CITY OF ALBUQUERQUE

Re: Project Name
3301 Candelaria Road NE
Traffic Circulation Layout
Engineer's/Architect's Stamp 08-12-2019 (G16D097)

Based upon the information provided in your submittal received 08-12-2019, the above referenced plan cannot be approved for Building Permit until the following comments are addressed:

1 Site Plan - Proposed
Scale: 1" = 20'-0"

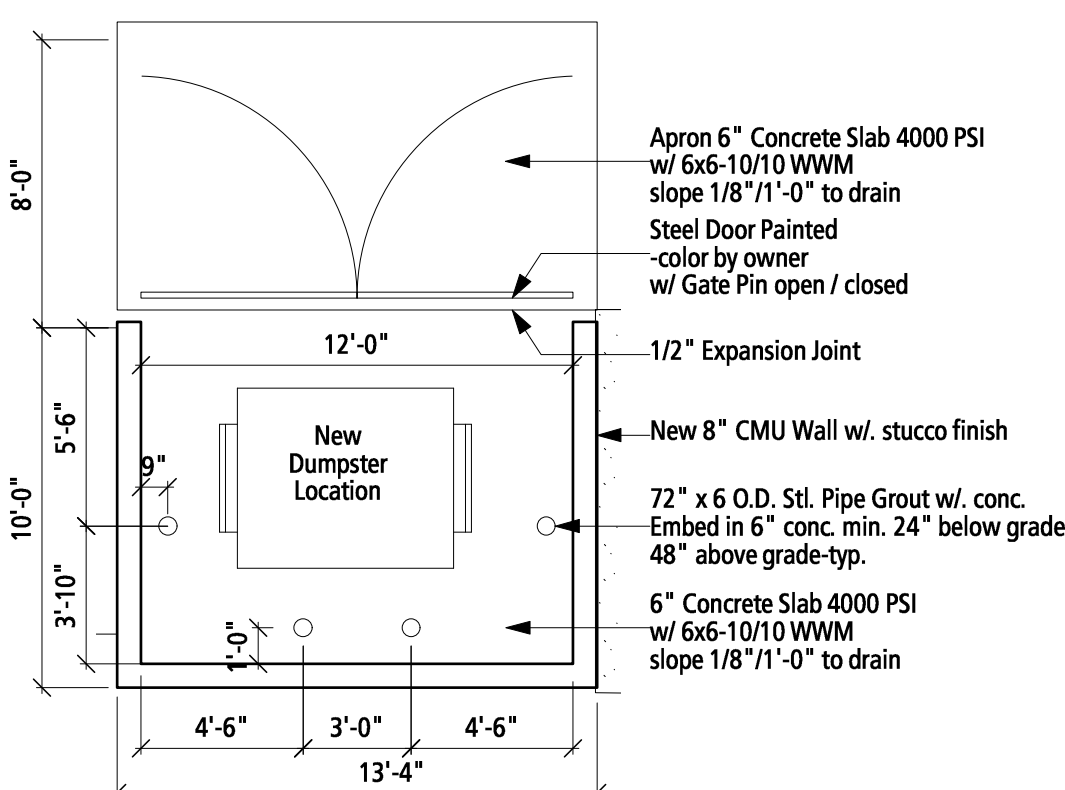
1. Part of the new drivepad portion is outside the property line.
2. List the number of parking spaces required by the zoning code as well as the proposed number of parking spaces including bicycle and motorcycle parking.

3. Please list the width for all proposed parking spaces. Some dimensions are not shown.
4. The ADA accessible spaces must include an access aisle. Van accessible aisles should be 8ft wide; all others should be 5ft wide.

10. A 5 ft. keyway is required for dead-end parking aisles.
11. Per DPM, a 6 ft. wide ADA accessible pedestrian pathway is required from the ADA parking stall access aisles to the building entrances. Please clearly show this pathway and provide details.
12. provide a copy of refuse approval.
13. It is not apparent what type of pavement surface is being proposed. A hard driving surface will be required as part of this proposed project for parking area and drive aisles.
14. Show the clear sight triangle and add the following note to the plan: "Landscaping and signage will not interfere with clear sight requirements. Therefore, signs, walls, trees, and shrubbery between 3 and 8 feet tall (as measured from the gutter pan) will not be acceptable in the clear sight triangle."

5 Motorcycle Sign Detail
Scale: 1/2" = 1'-0"

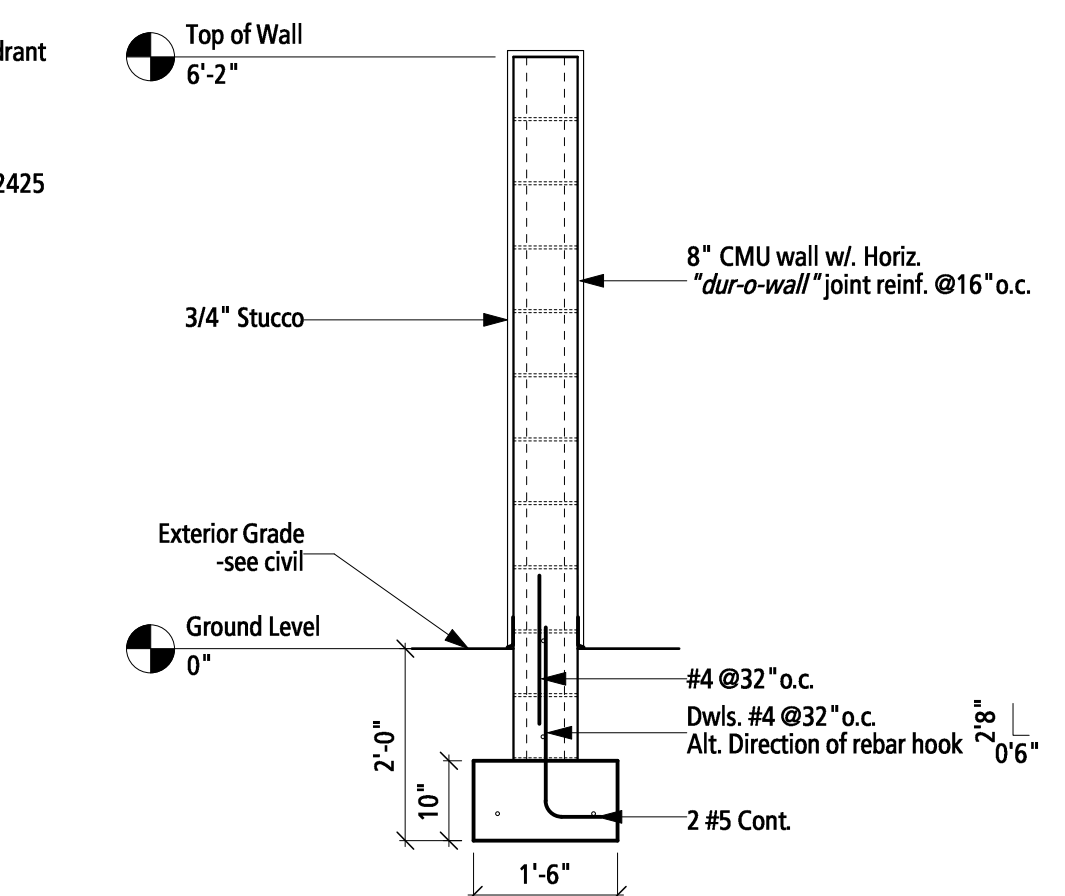
5. Motorcycle parking spaces shall be designated by its own conspicuously posted upright sign, either free-standing or wall mounted per the zoning code.
